FINAL PLAT

RE: SUB 2000-79 -- One-Step Final Plat of CEDAR VIEW SECOND ADDITION

RE: SUB 2000-79 -- One-Step Final Plat of CEDAR VIEW SECOND ADDITION

CASE NUMBER: SUB 2000-79 -- CEDAR VIEW 2ND ADDITION

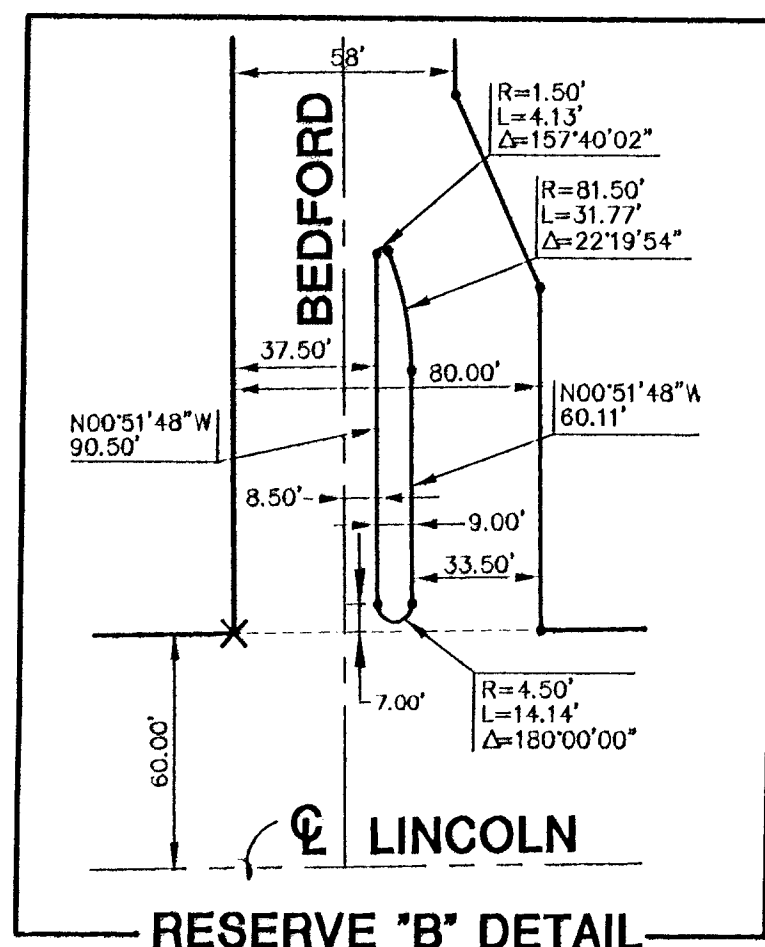
- E. City Engineering needs to comment on the status of the applicant's drainage plan. A drainage plan is needed. A minimum pad elevation needs to be platted adjacent to Reserve A.

- F. The right-of-way of the Kansas Turnpike and Condemnation Case number should be denoted.
- G. The applicant shall dedicate complete access control along the Kansas Turnpike.

- H. A minimum pad elevation should be denoted as was platted in the Cedar View Addition unless this requirement has been revised.
- I. Provisions shall be made for ownership and maintenance of the proposed reserves. The applicant shall either form a lot owners' association prior to recording the plat or shall submit a

- L. The use of Reserve A for utilities located within the platted easements should be referenced in the plat's text.
- M. The legal description should delete reference to the southwest quarter.

- N. The corner tie point should reference the "SW corner of the NW quarter".
- O. The section center should be located on the final plat tracing.
- P. A legend should be included on the final plat tracing.

- Q. City Fire Department shall comment on the acceptability of the plat's street names. *The northernmost cul-de-sac needs to be revised to Bedford Circle.*

- R. For Lots 1-5 and 29-31, the lots exceed the maximum lot width to lot depth ratio of 2.5 to 1. A modification will need to be approved. *A modification has been approved.*

- S. City Fire Department needs to comment on the length of Bedford which exceeds the 600-ft maximum length for cul-de-sac streets. *The length of the street is acceptable.*

- CC. The representatives from the utility companies should be prepared to comment on the need for any additional utility easements to be platted on this property. *KGE has requested additional easements.*
